RE: Lot 3 Block 5 Unit 19, S.A.D. 228
Volcano Cliffs Subdivision
6516 Onyx Dr. NW
Grading and Drainage Plan
Engineers Stamp Date 4/10/2018
Rev GP for Pool, 3/7/2022 (E10D044)

Based upon the information provided in your submittal received 3/18/2022, this plan is approved for Revised Grading Permit.

LANG - GRADING & DRAINAGE PLAN

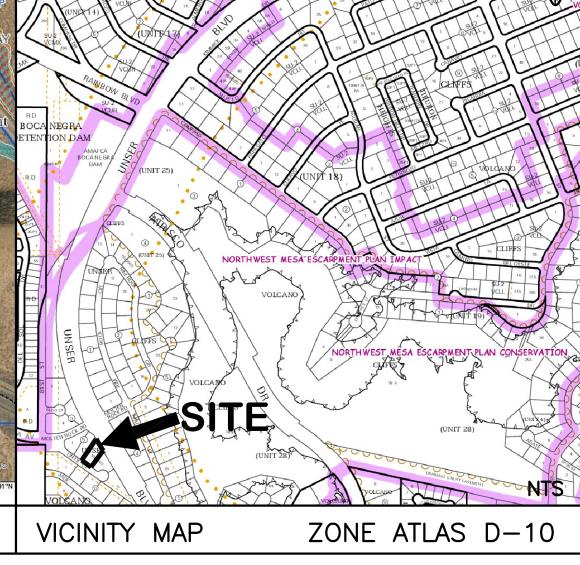
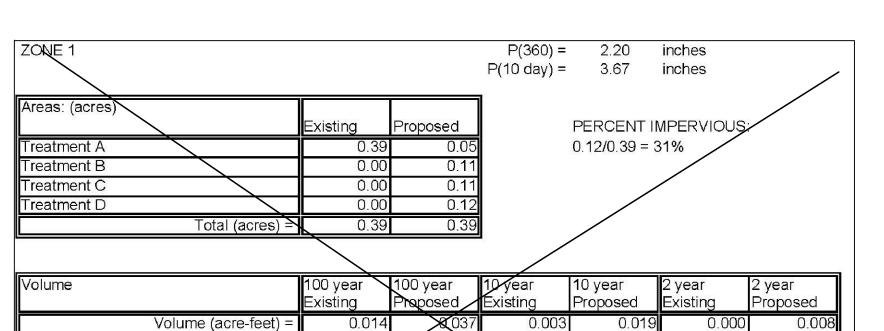
Advise the owner contractor not to use dirt as a ramp to climb the curb, use lumber or crusher fines for this purpose. Place this note on the plan.

Reiterate to the Owner/Contractor that a separate permit for a garden/retaining wall must be obtained with the approved G&D plan and Pad Certification. Also, if a swimming pool is to be placed after this approval a new grading and drainage plan will need to be resubmitted showing the changes for the land treatments.
